DOUBLE MARKING ON MODULAR SYSTEMS

Frank Brouwers

Current situation: Proposal for the 01 series of amendments to phase 1 of R129 (ECRS)

EXAMPLE: Module mark:

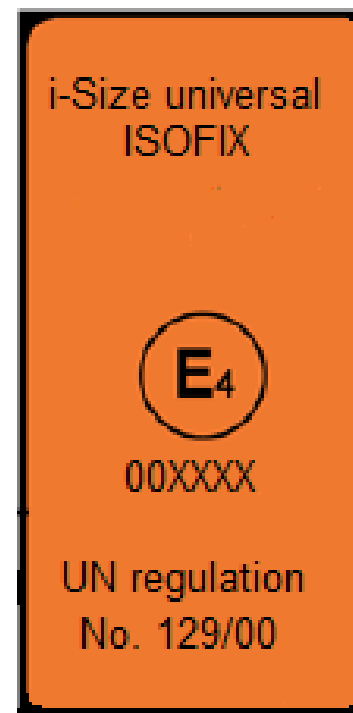
5.4.3. An international module mark consisting of:

5.4.3.1. A circle surrounding the letter "E" followed by the distinguishing number of the country which has granted approval²;

5.4.3.2. An approval number, the words "Regulation No." followed by the number of this Regulation, a slash and the series of amendment ("Regulation No. 129/00");

4.6.3.3. The words Module "name of the Module", depending on the name of the module of Enhanced Child Restraint System;

4.6.3.4. The size range including maximum weight for which the Module of the Enhanced Child Restraint System has been designed;

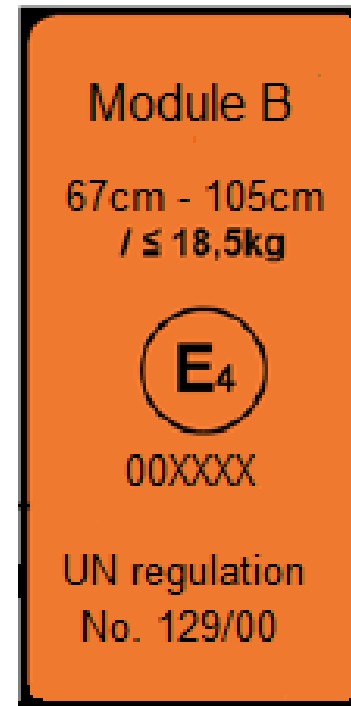
Approval mark ECRS

Approval mark ECRS
 Module and base

1. Approval mark (one approval: one base - two modules).

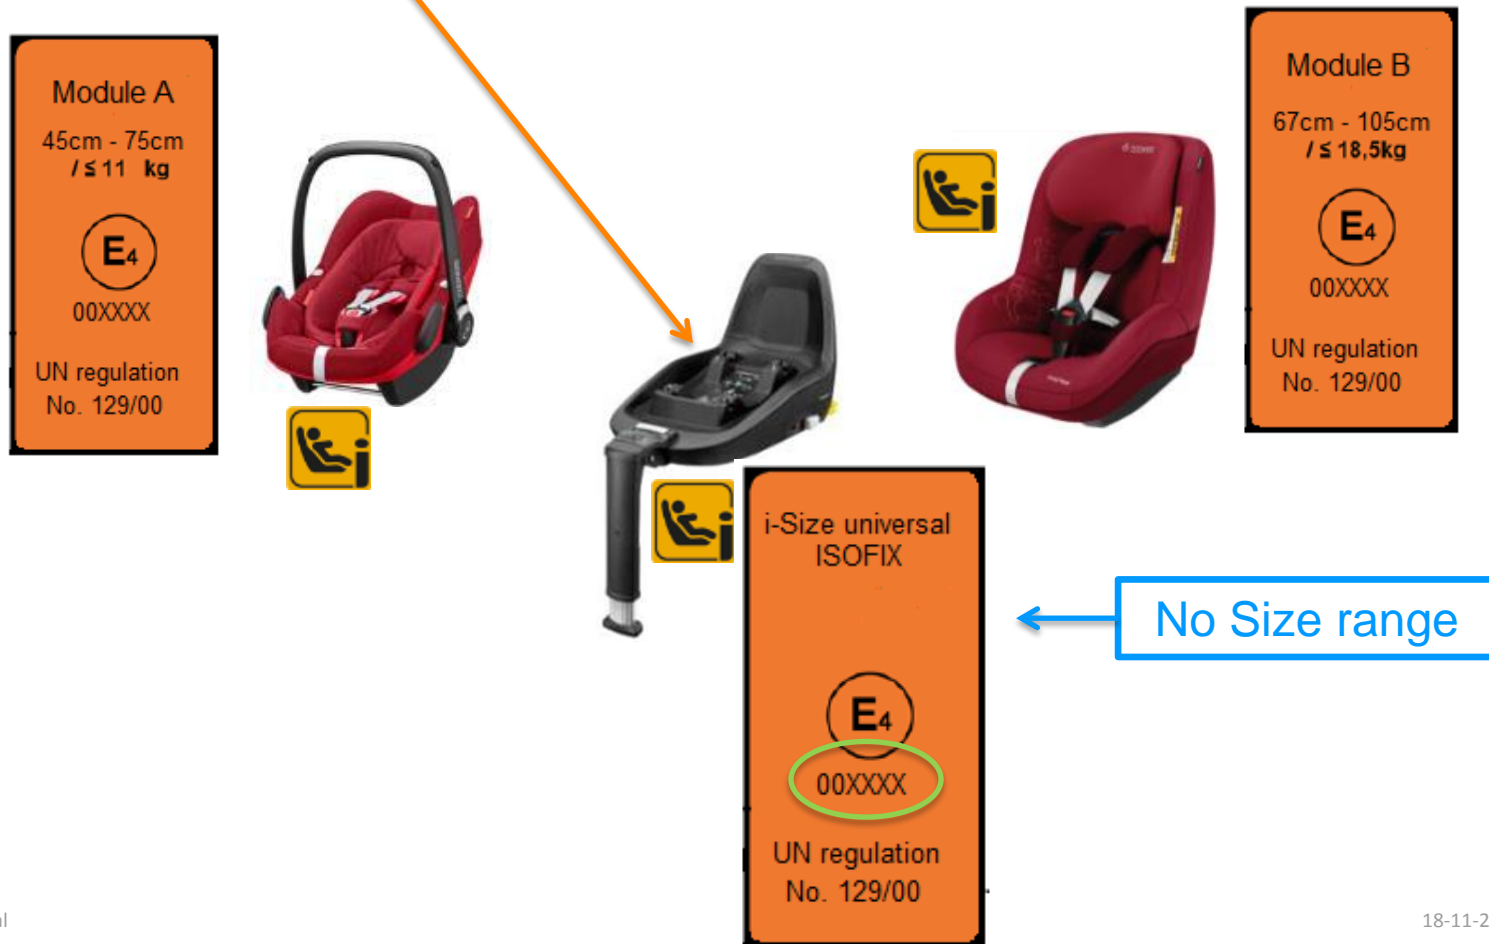
Approval mark shall be located on the part of the ECRS which includes the ISOFIX connectors.
